**STATE OF TENNESSEE
DEPARTMENT OF TRANSPORTATION**

INSTRUCTIONAL BULLETIN NO. 21-20

Regarding Various Revised, New and Voided Standard Drawings

Effective May 13, 2022 letting (March 2, 2022 Turn-in), the following Standard Drawings have been revised or are new. In addition, the Roadway Design Guidelines Chapter 7 – Item Numbers, Sections 7-611.00, Manholes, Catchbasins, Inlets and Pipe End Walls, and Section 7-705.00, Guardrails, of the Roadway Design Guidelines has been modified to reflect any changes to or new item numbers in the Standard Drawings of this Instructional Bulletin.

D-CBB-42	10-29-21	CAST IRON GRATE DETAILS FOR NOS. 42, 43 & 44 TYPE CATCH BASINS
----------	----------	--

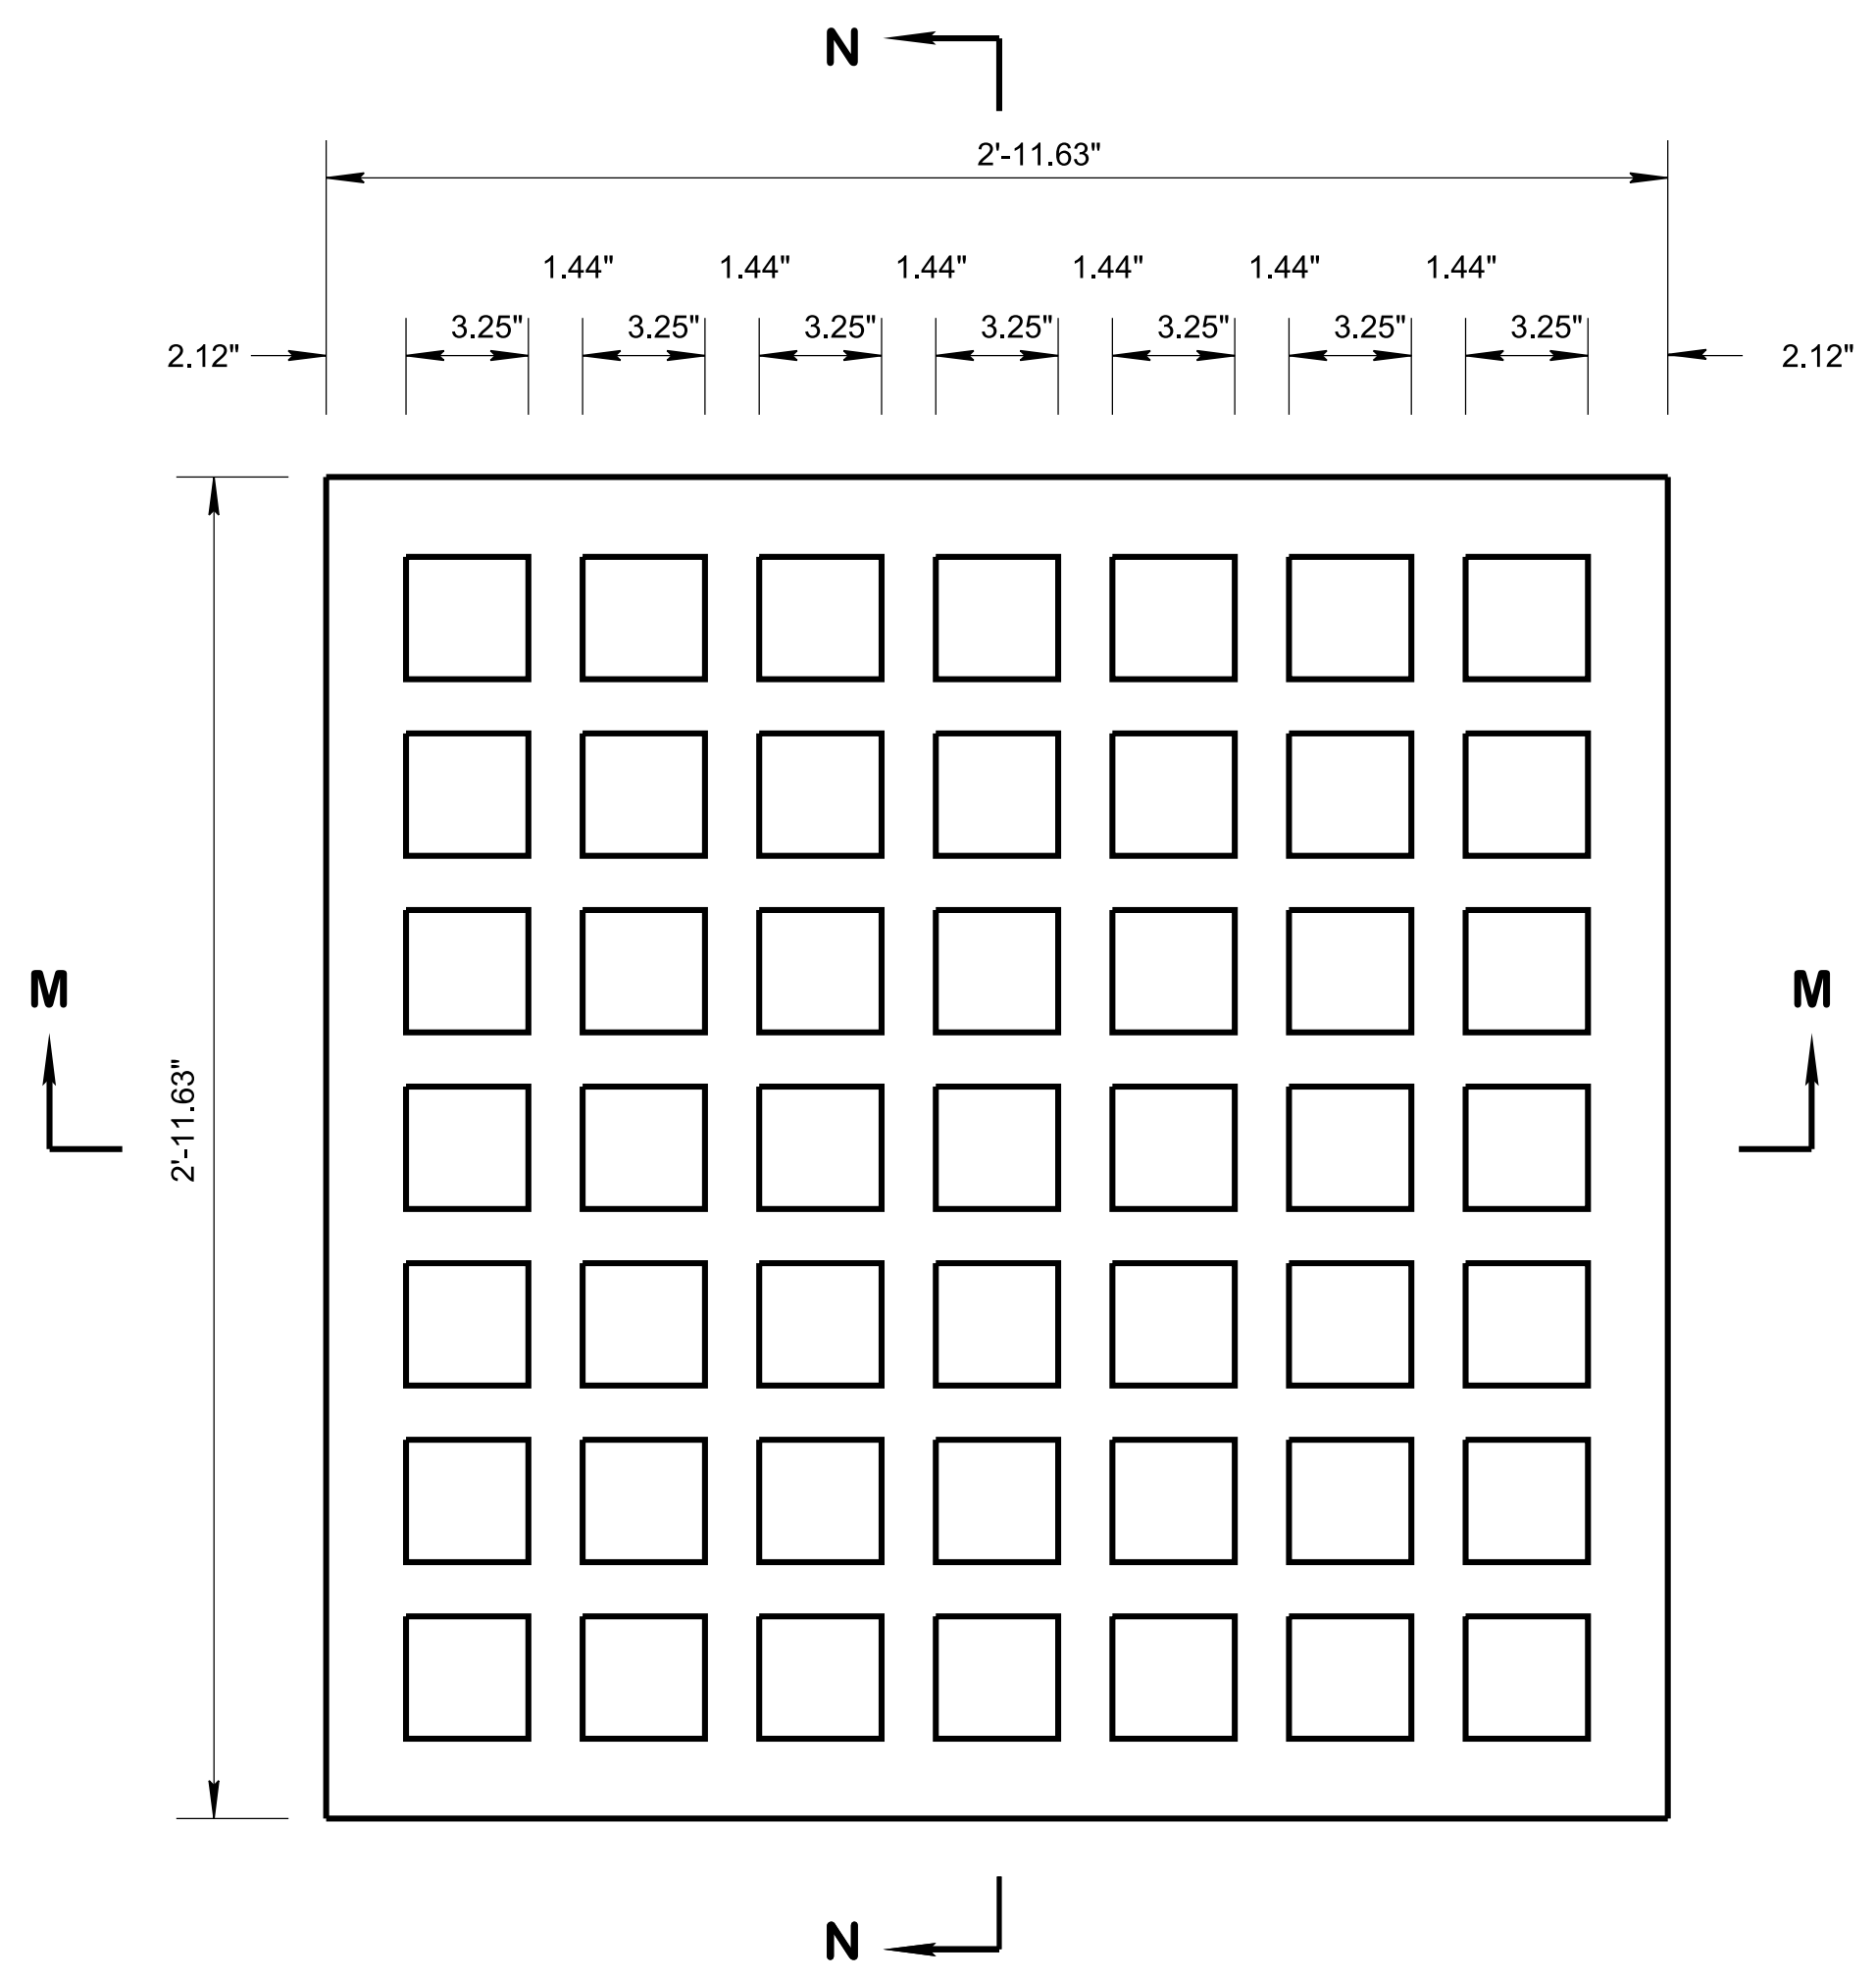
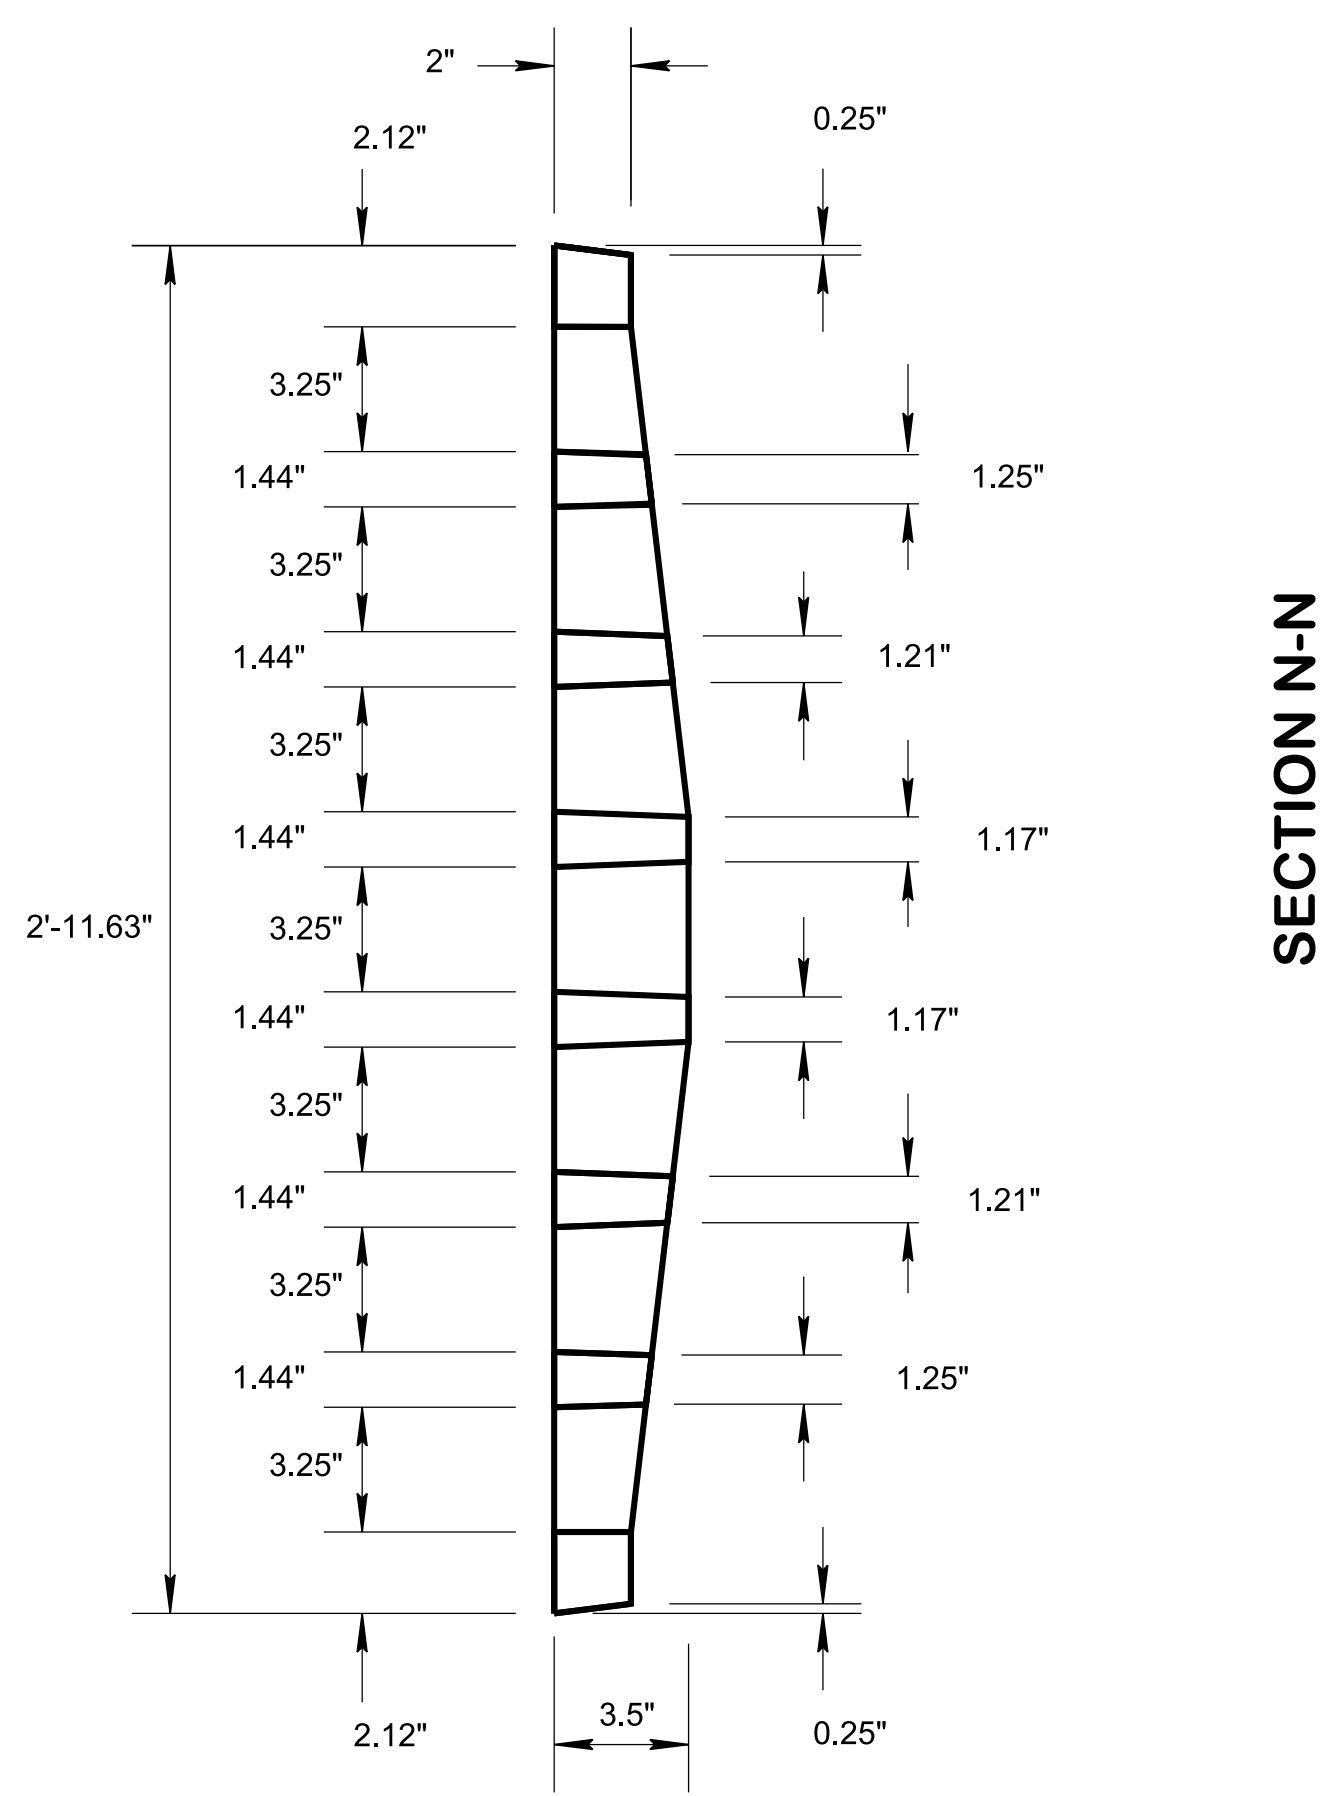
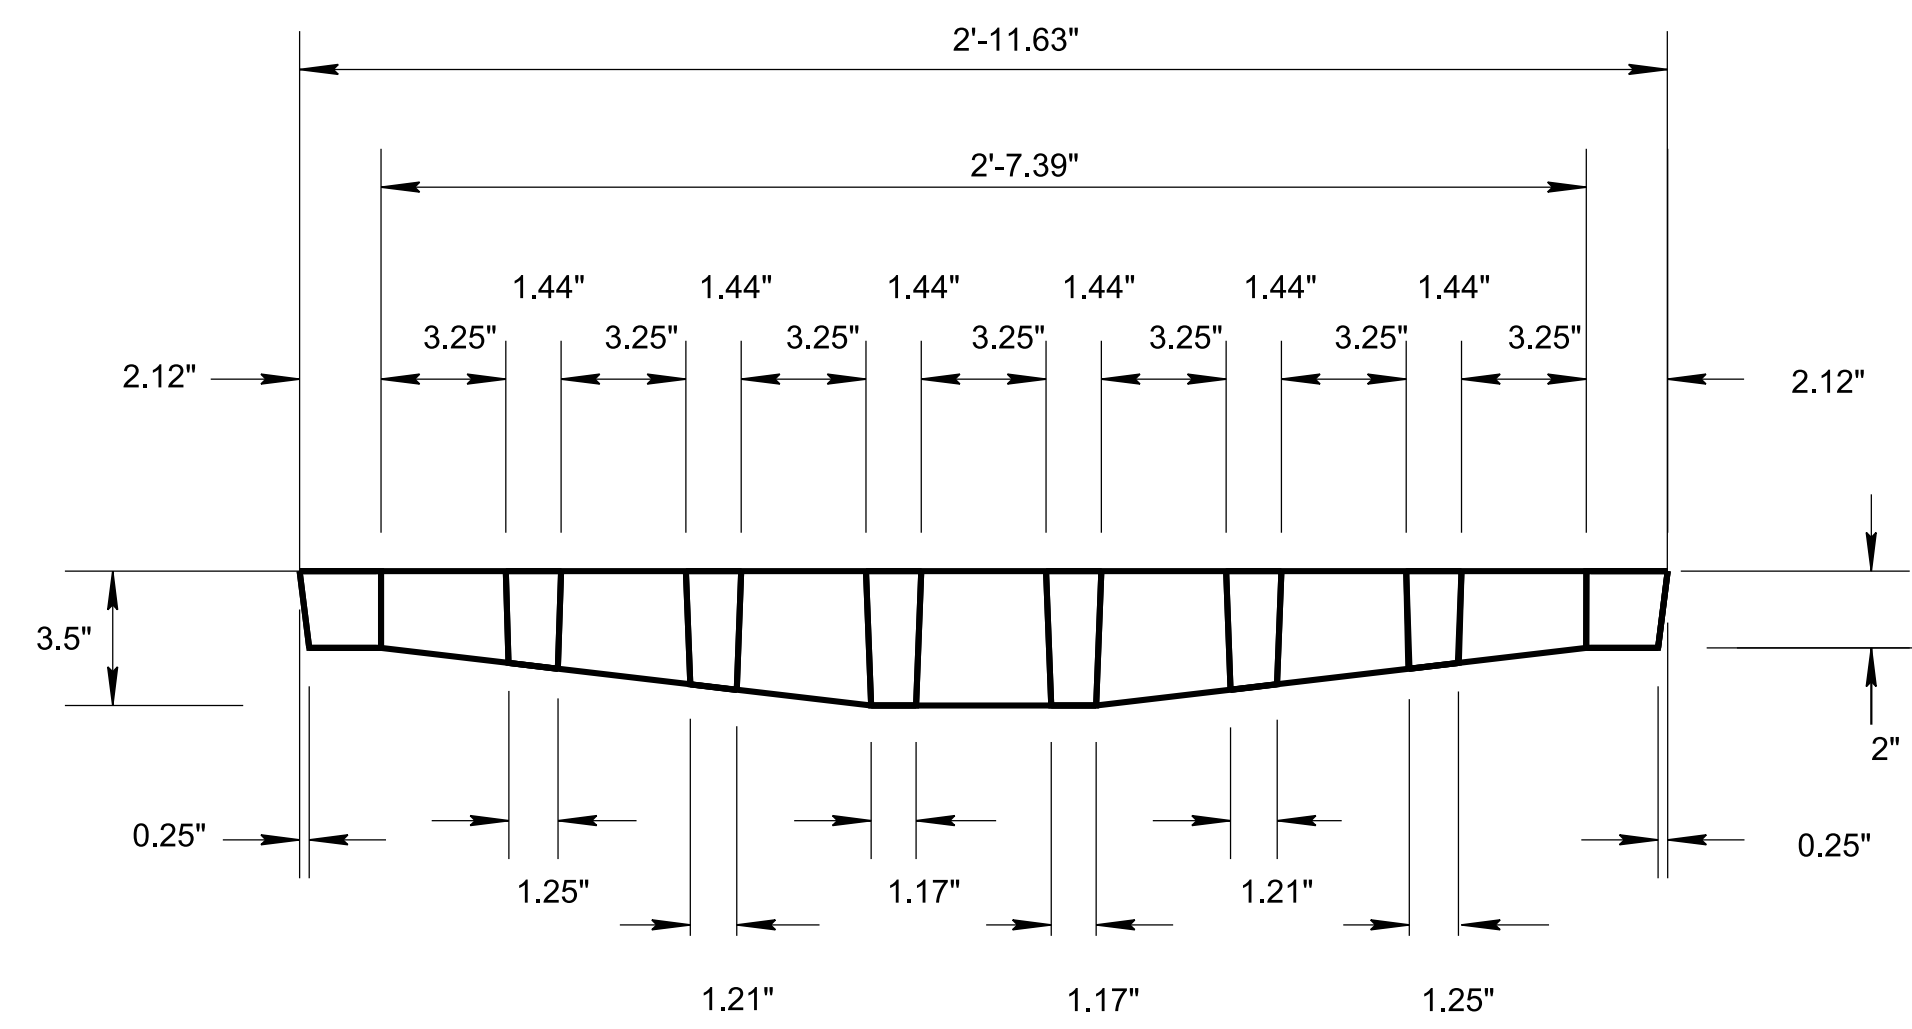
REV. 5-27-98: CHANGED WEIGHT OF GRATE UNIT FROM 485 TO 459 POUNDS.
 REV. 10-26-99: MODIFIED FIRST GENERAL NOTE.
 REV. 5-27-01: CHANGED GENERAL NOTE (D).
 REV. 02-20-2020: REDREW SHEET.
 REV. 03-04-2021: ADDED GENERAL NOTE (E) REVISED GENERAL NOTE (A) AND REMOVED WEIGHT PER GRATE TABLE FROM THE DRAWING.
 REV. 10-29-21: REVISED GENERAL NOTE (E).
